**12.8' x 6.4' LED Display – Edmunds Conference Room
Northern Maine Community College Request for Proposals
Questions and Responses**

6/22/2020

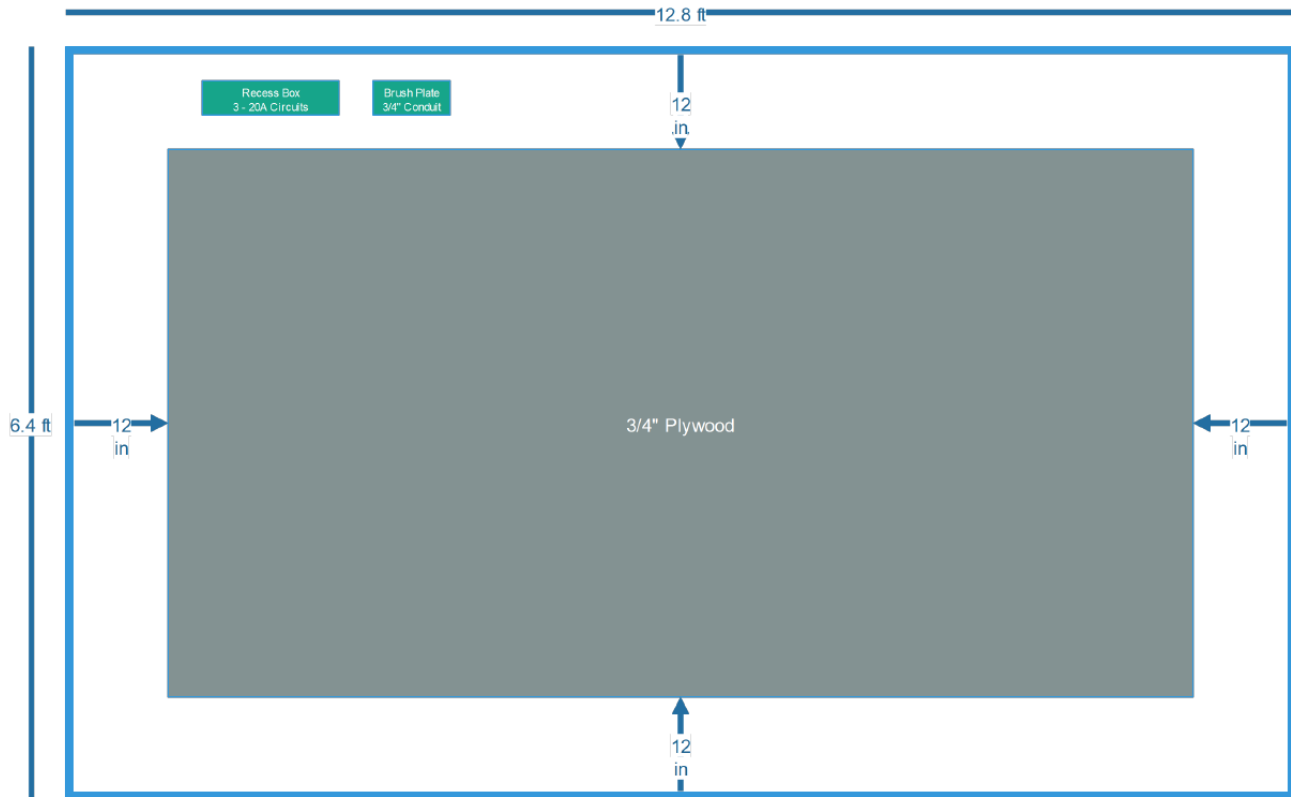
Q11. What is the acceptable size tolerance based upon the intended application?

R11. As it relates to pitch 2.9 is the minimum specification. Bidders may submit multiple bids on separate displays.
